DECISION NO. RRJ0000-OR-470-7229

for replacement of the bolts providing the reduced tightness in the connection joint of the attachment mounts with the horizontal stabilizer hinge bracket on the RRJ-95 aircraft

**Procedure for
replacement of T7.92.3100.077.000.73 hollow bolts to T7.92.3100.177.000.73 bolts**

Demounting of the hollow bolt (T7.92.3100.077.000.73) along the lower hinge fitting of the stabilizer
Figure 3 (sheet 1 of 3)

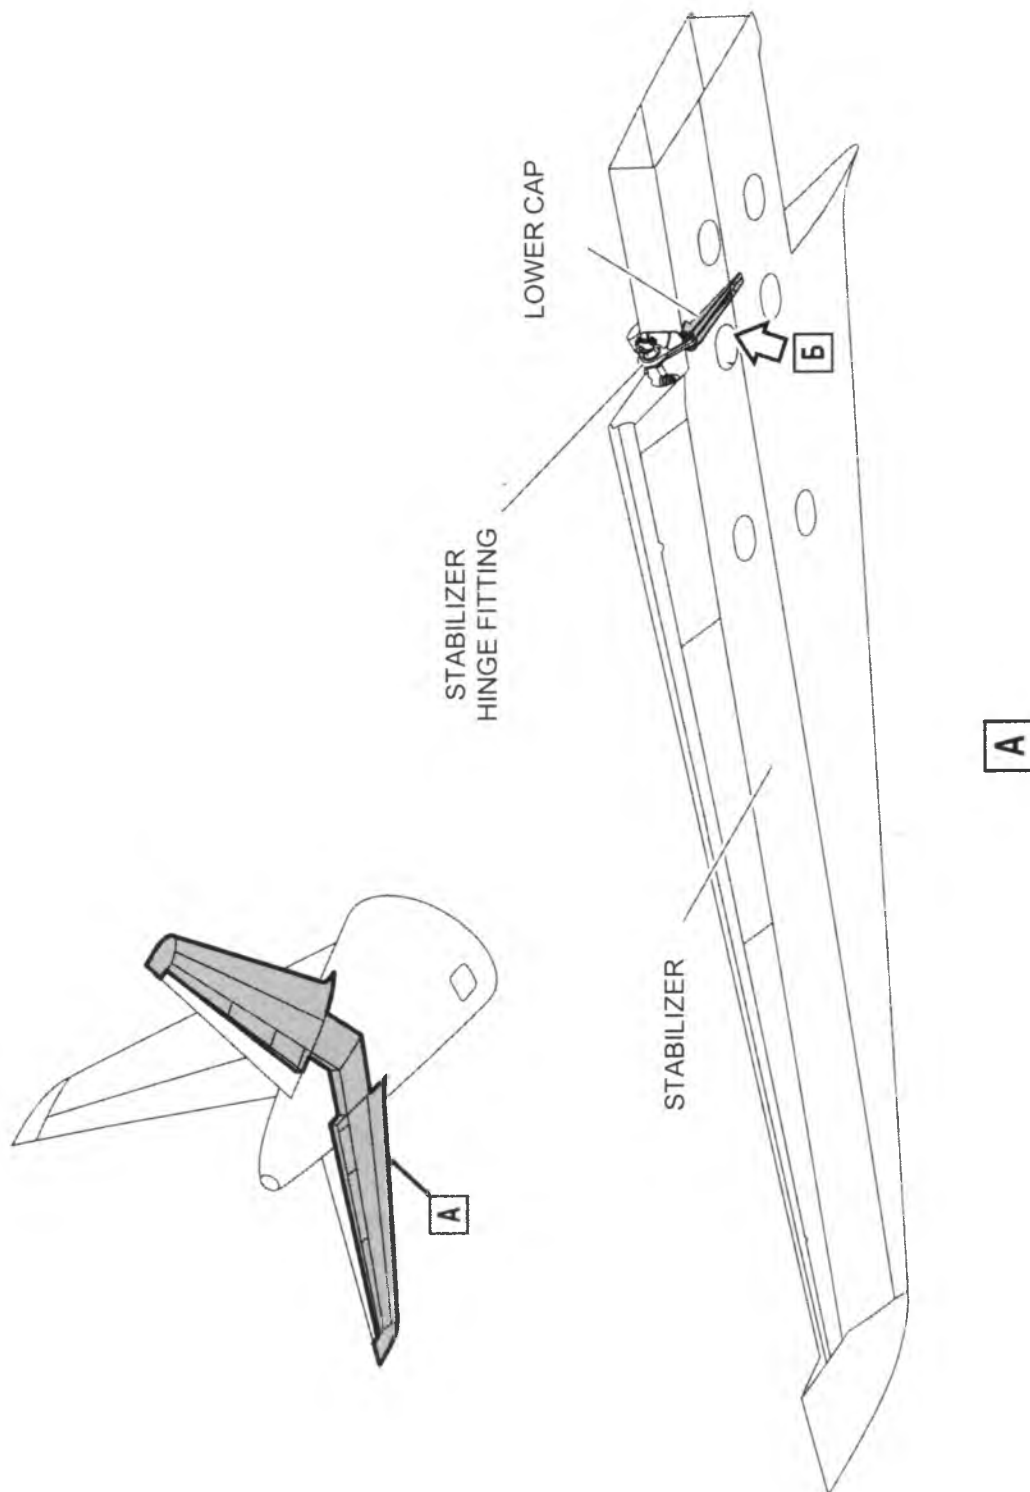
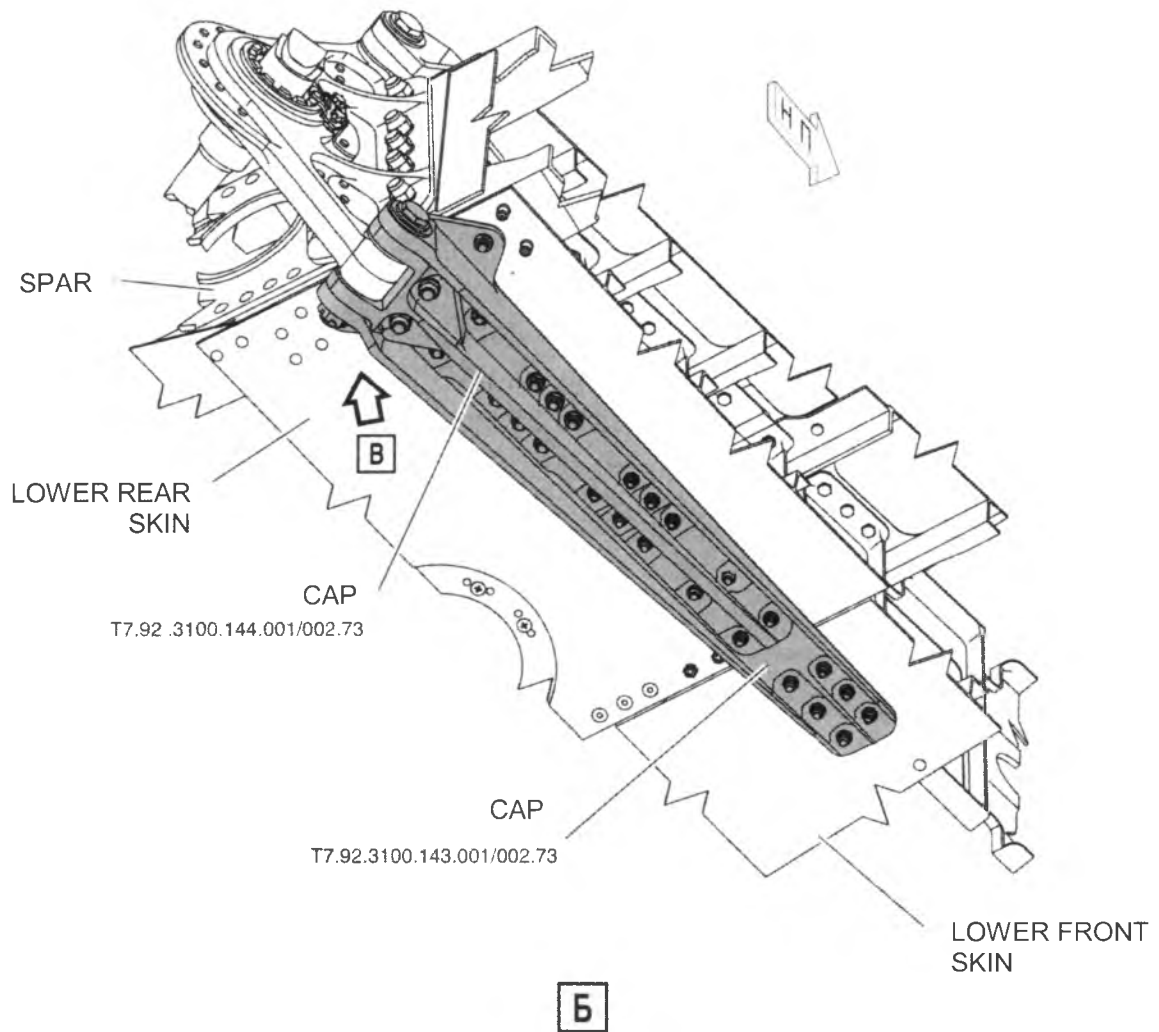
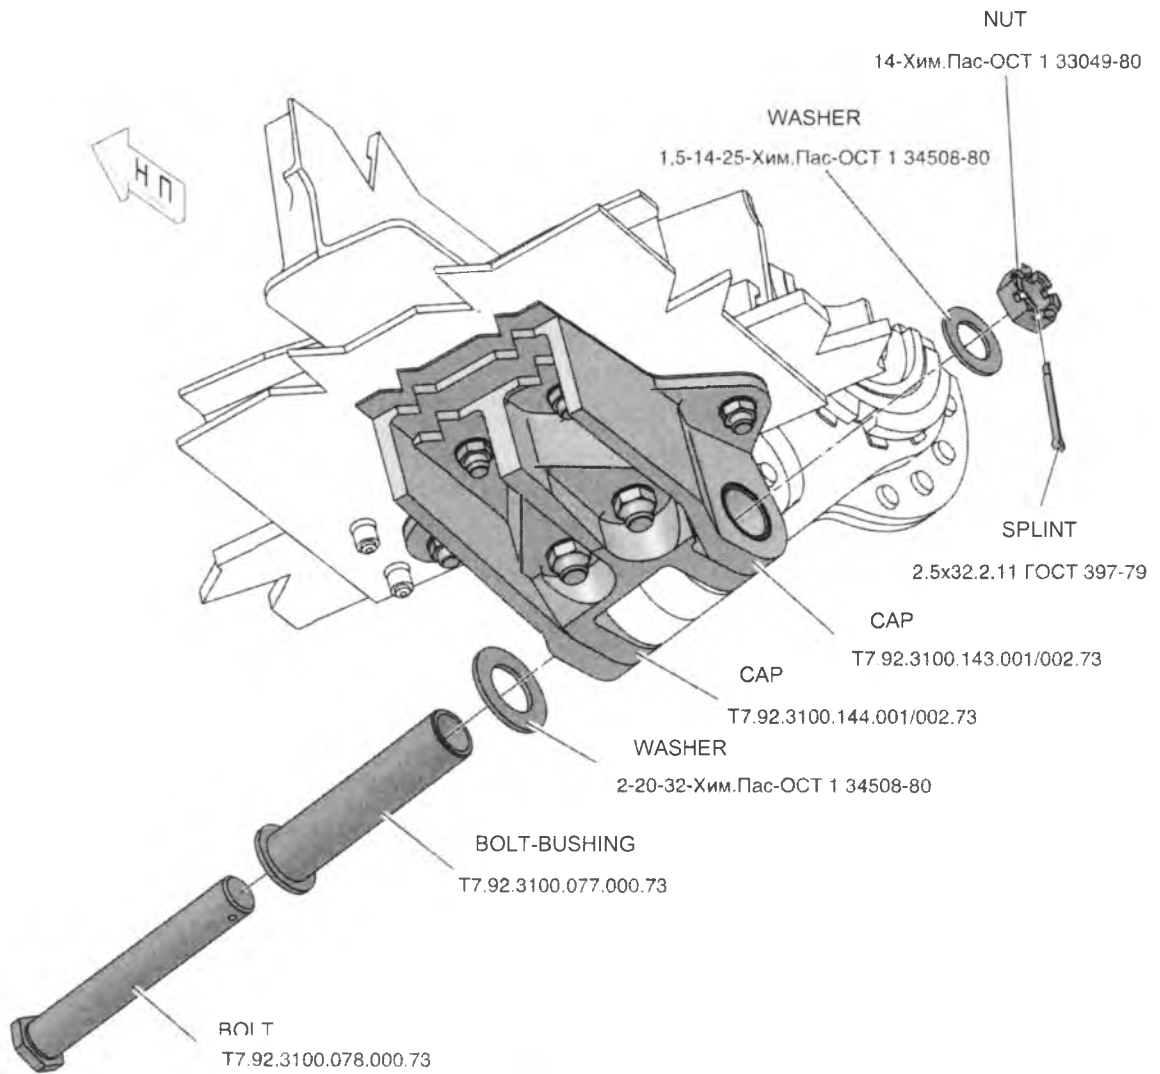
- (3) Demounting the hollow bolt (T7.92.3100.077.000.73) along the lower hinge fitting of the stabilizer (see Fig. 3).
- (a) Clean the surfaces of the upper cap from a dirt with the cleaning rags dampened with НЕФРАС-С2-80/120 solvent if necessary.
 - (б) Remove the 2,5x32.2.11 ГОСТ 397-79 splint and discard.
 - (в) Remove the 14-Хим.Пас-ОСТ 1 33049-80 nut of the lower cap attachment to the fitting of the stabilizer. Save it the nut for the further installation.
 - (г) Remove the 1,5-14-25-Хим.Пас-ОСТ 1 34508-80 washer and save it for the further installation.
 - (д) Remove the bolt (T7.92.3100.078.000.73) and save it for the further installation.
 - (е) Carefully remove the bolt-bushing (T7.92.3100.077.000.73) from the lugs of the lower cap. Discard the bolt-bushing.
 - (ж) Remove the 2-20-32-Хим.Пас-ОСТ 1 34508-80 washer and save it for the further installation.

Installation of the hollow bolt (T7.92.3100.177.000.73) along the lower hinge fitting of the stabilizer
Figure 4 (sheet 1 of 3)

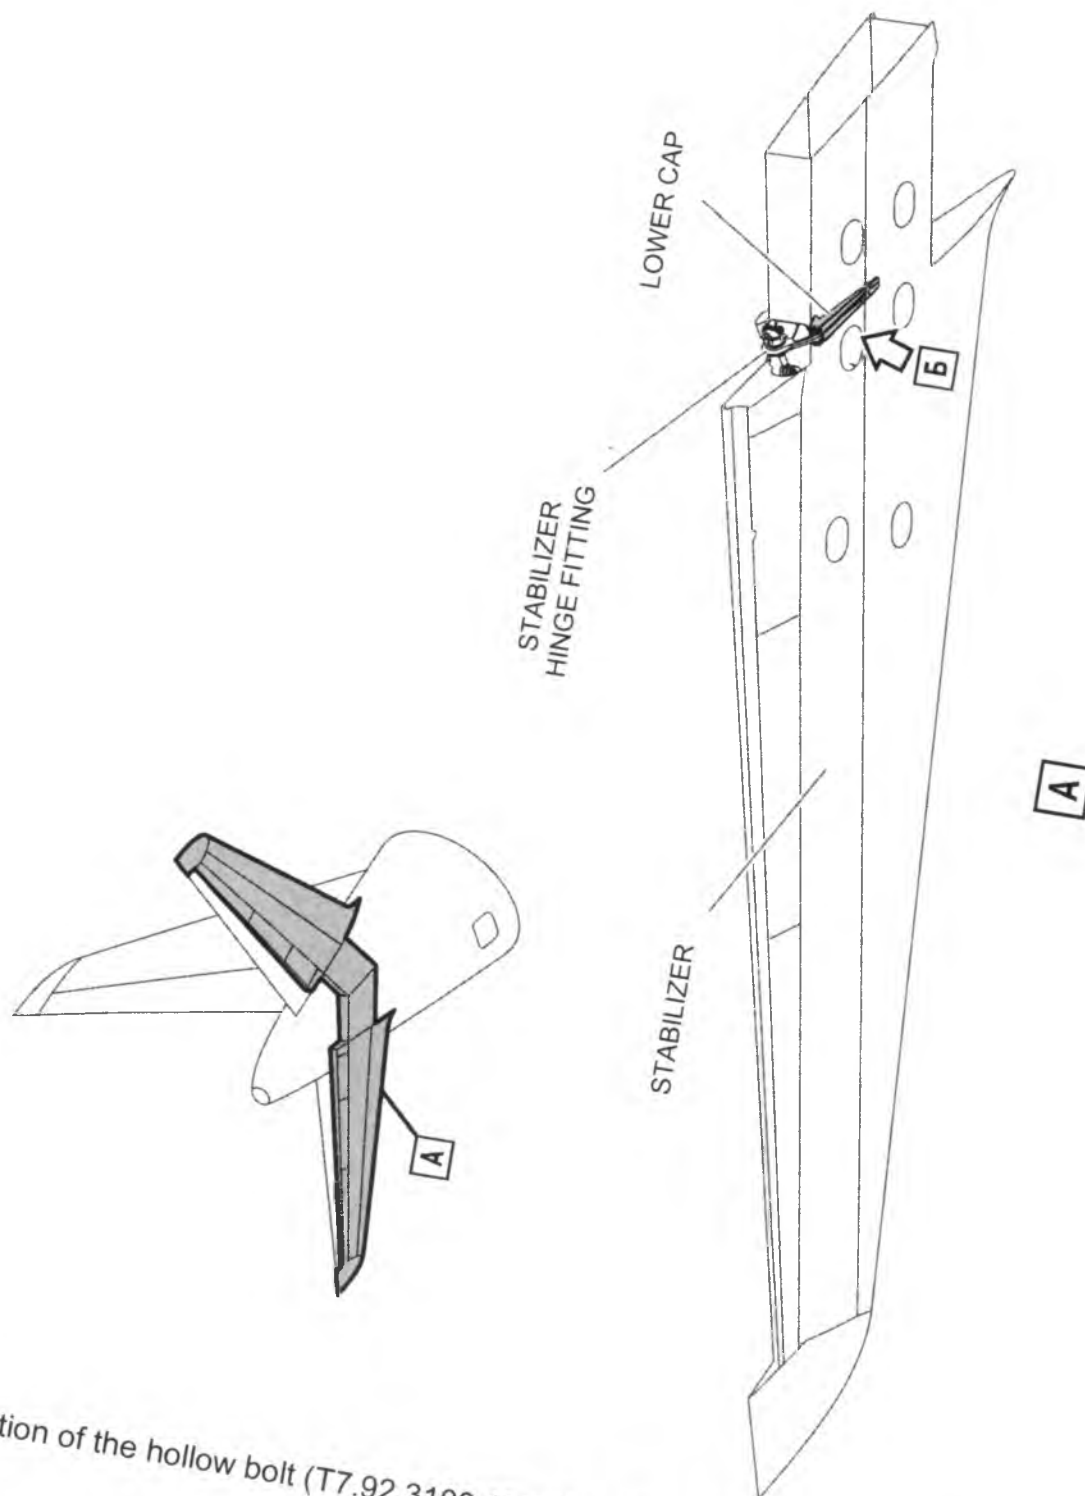
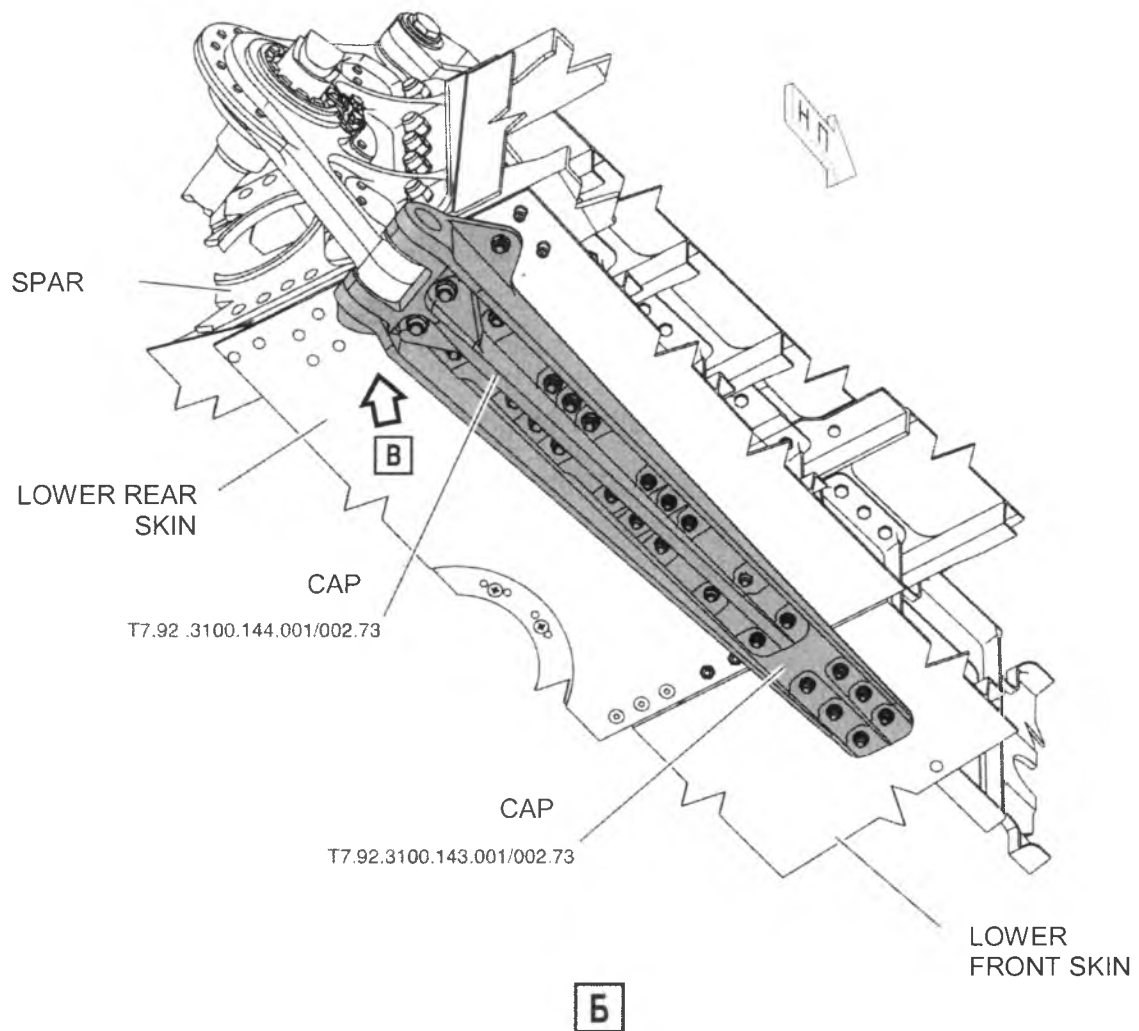
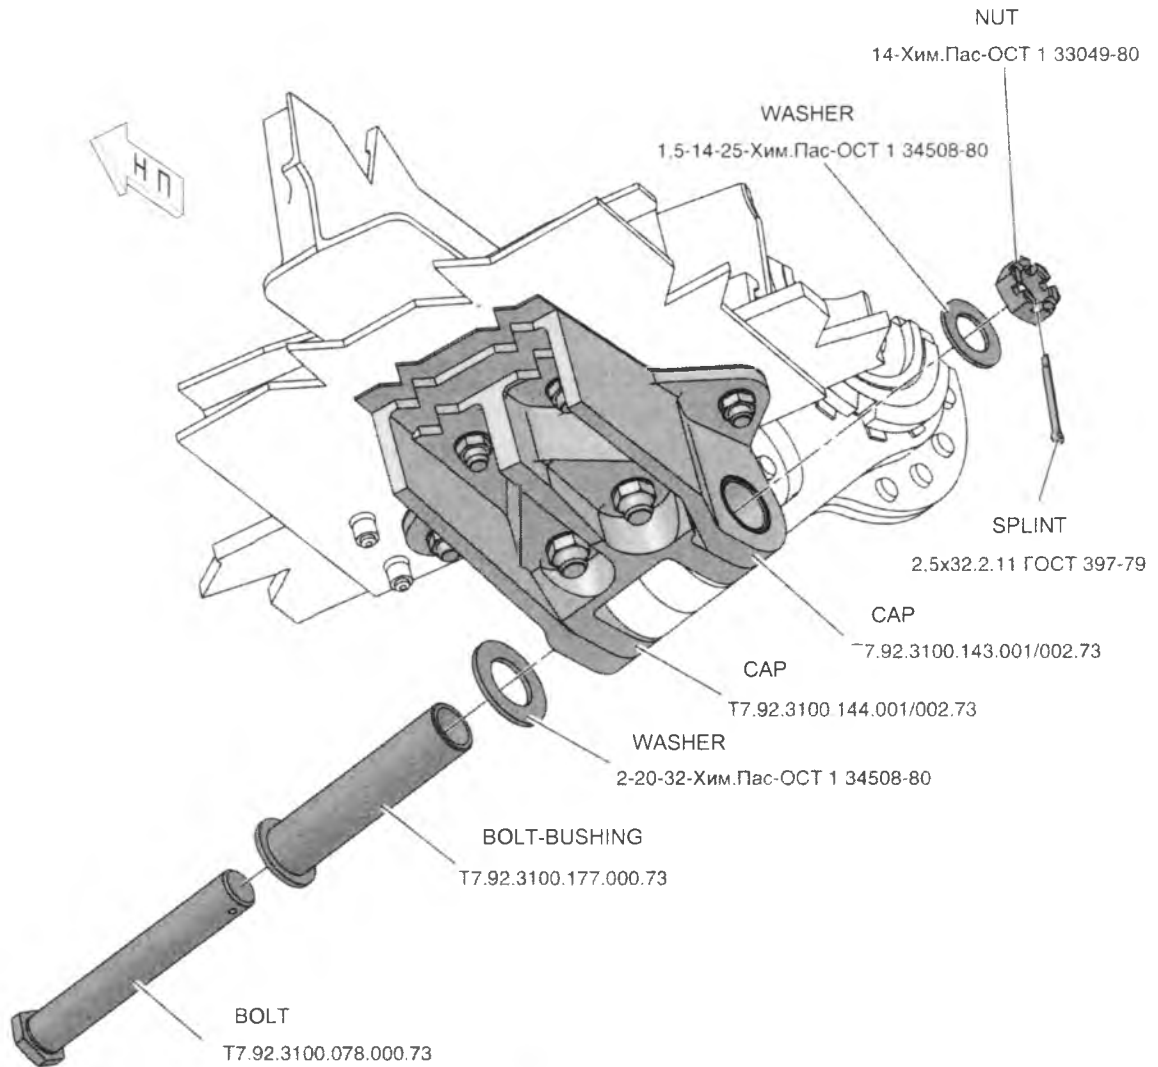
(4) Installation of the hollow bolt (T7.92.3100.177.000.73) along the lower hinge fitting of the stabilizer (See. Fig. 4).

- (a) Install the previously removed 2-20-32-Хим.Пас-ОСТ 1 34508-80 washer and new bushing (T7.92.3100.177.000.73) to the lug of the lower.

- (б) Install the previously removed bolt (T7.92.3100.078.000.73).

- (в) Install the previously removed 1,5-14-25-Хим.Пас-ОСТ 1 34508-80 washer.

- (г) Install the previously removed 14-Хим.Пас-ОСТ 1 33049-80 nut.

- (д) Install new 2,5x32.2.11 ГОСТ 397-79 splint.
